Job 72281245REP1	Truss A6	Truss Type Truss	Qty 2	Ply 1	SDH - LANCASTER CFI RANCH NO TRAY Job Reference (optional)
---------------------	-------------	---------------------	----------	----------	---

Repair for a crack in the bottom chord where indicated.

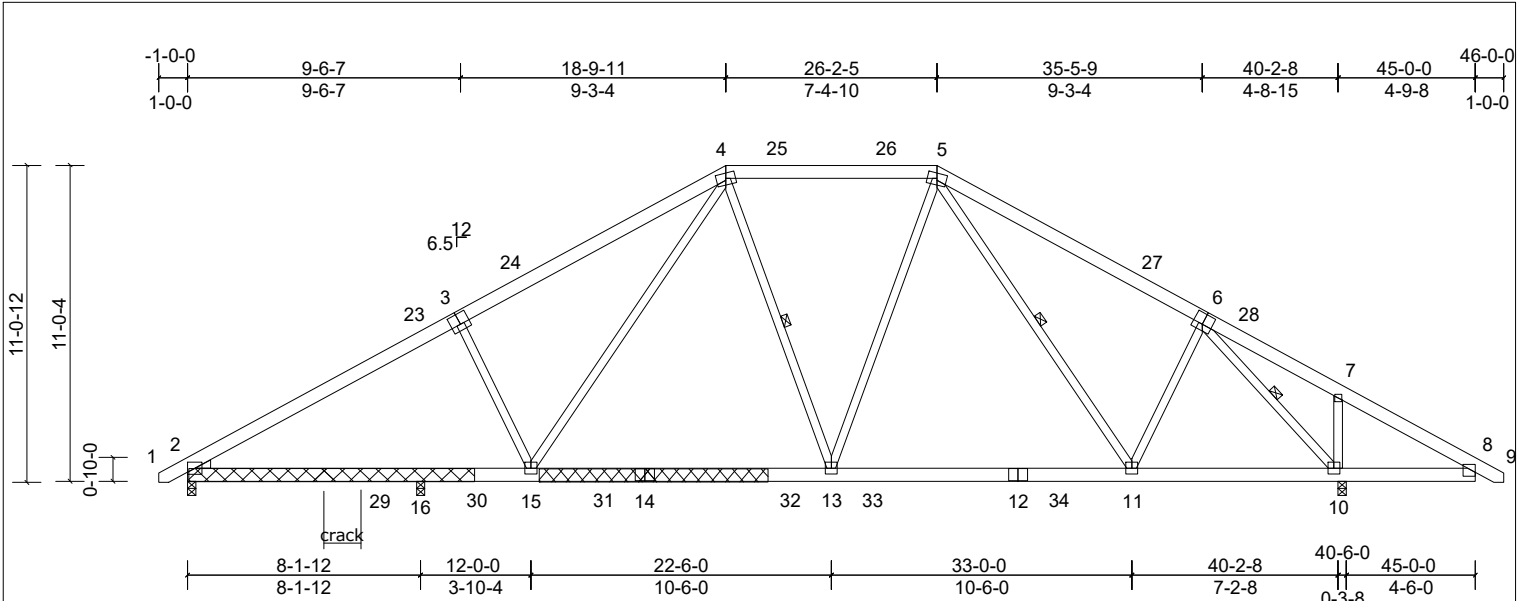
Repair for a break in the bottom chord at the plate at joint 14.

Attach 2x6 x 10' SP or SPF No.2 scab to each face of truss as shown with 2 rows of 10d (.131" x 3") nails spaced 4" oc

Attach 2x6 x 8' SP or SPF No.2 scab to each face of truss centered at the brea = with 2 rows of 10d (.131" x 3") nails spaced 4" oc
